ADMINISTRATIVE STAFF REPORT

SUBJECT: **Development Design Review and Minor Modifications, Permit No. PZ 21-200-03:**
Located West of Oxnard Boulevard and North of the Union Pacific Railroad in Lot 1 of Tract 5745-2 in Planning Area 6 of the Village Specific Plan (Wagon Wheel Project Area). Assessor's Parcel Number 139-0-610-355. Filed by Oxnard CRFL Partners LLC (Oakwood Communities Inc.)

PARK PLACE: DEVELOPMENT DESIGN REVIEW

ARCHITECTURAL SITE PLAN PARK PLACE LOT I

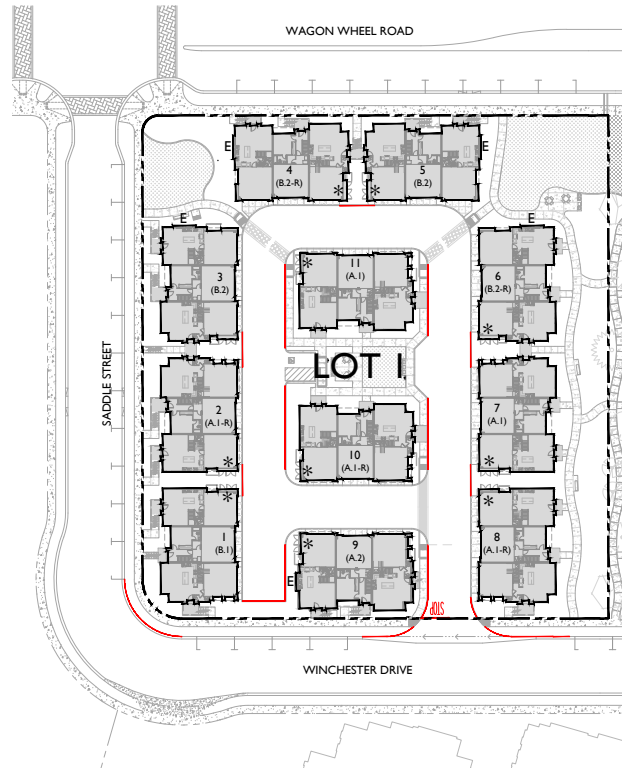
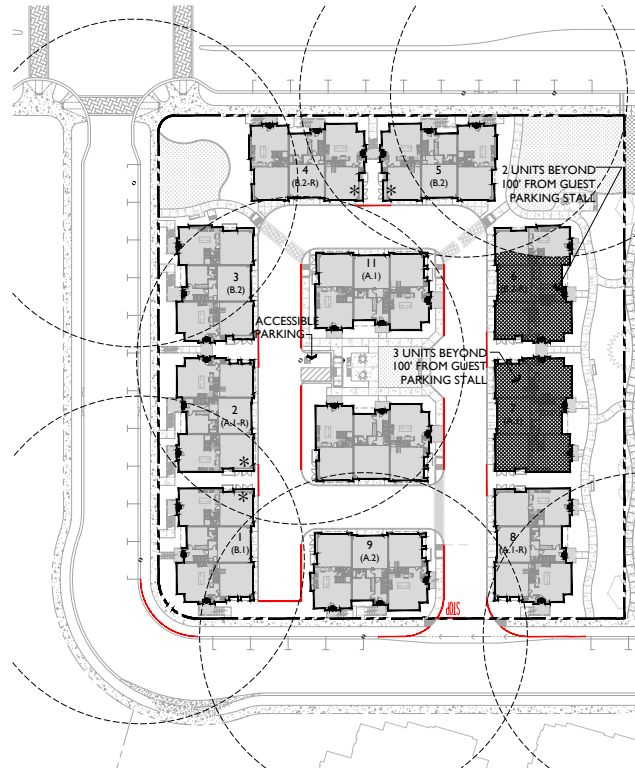
Pedestrian paths connect the buildings throughout the project area and to adjacent pedestrian pathways. As shown on Sheet A-1 (Architectural Site Plan), 5 ft wide pedestrian paths are proposed through the site and around the perimeter of the buildings. A meandering path is provided on the east side of Building 6, 7 and 8 to provide pedestrian access from Winchester Drive and Wagon Wheel Road; this walkway connects in two locations with the walkway on the west side of Lot 5. The development includes a 3,000 square-foot common open space lawn area on the northeast corner of the site. Other open space amenities include picnic tables, benches, BBQ and a hot ash receptacle (See Sheets L1 & L2). A mailbox kiosk is proposed adjacent to a parking space reserved for USPS near the center of the development.

A-2

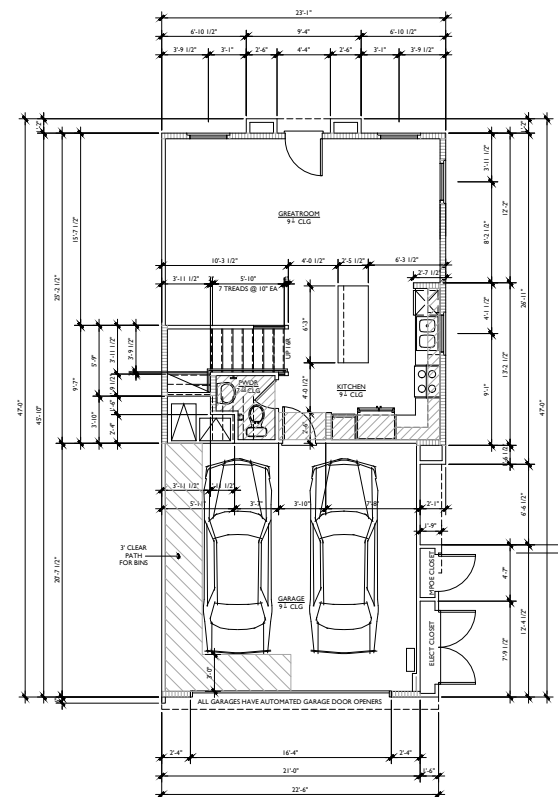
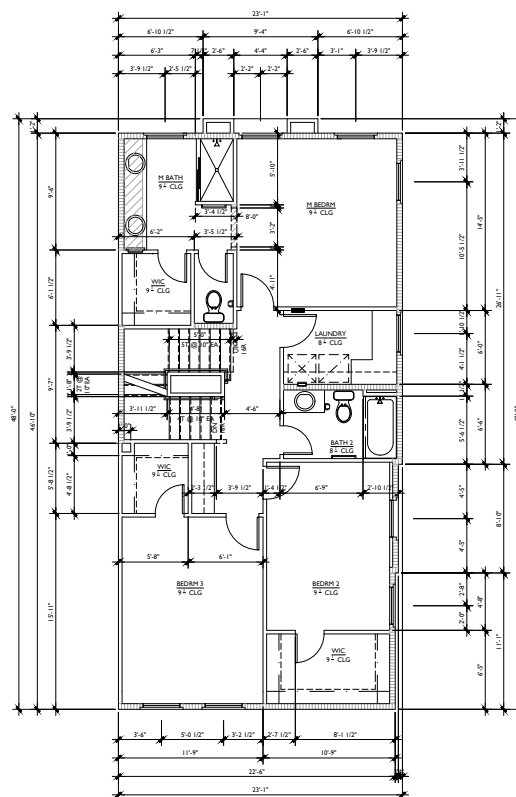
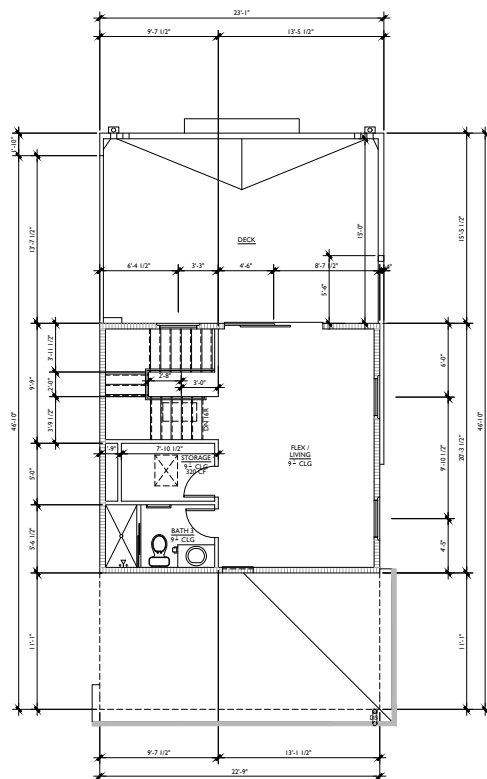
As shown on Sheet A-2 (Guest Parking Diagram), the project provides one off-street accessible visitor parking spaces, and 26 standard parallel parking spaces on the public right-of-way on Wagon Wheel Road, Saddle Street and Winchester Drive, for a total of 27 visitor parking spaces. A minimum of 17 guest parking spaces are required.

1. Guest Parking Distance. OCC 16-645 (Location of Parking Spaces) requires that visitor parking spaces be located within 100 feet of condominium unit entry. As shown on Sheet A-2 (Guest Parking Diagram), two units in Building 6 and three units in Buildings 7 are located between 110 and 145 feet from visitor parking.

Guest Parking Distance Analysis: Staff has evaluated the request and has determined that the requested Minor Deviation is in keeping with the spirit and intent of the Specific Plan, as allowed under VSP Section 8.7.2.1.3. As shown on Sheet A2 (Guest Parking Diagram), due to the configuration of the site, some units on the west side of the development facing the paseo are located slightly further than 100 feet from guest parking, which is located around the north, south and east perimeter of the

- i. Guest Parking Distance: Allow 5 units (less than 15% of units) to be located greater than 100 feet from visitor parking. [OCC 16-645 Location of Parking Spaces]
- ii. Trash storage location: Allow storage of individual trash cans inside of individual garage units rather than outside, in keeping with the spirit and intent of the Specific Plan (VSP Section 4.4.1.)
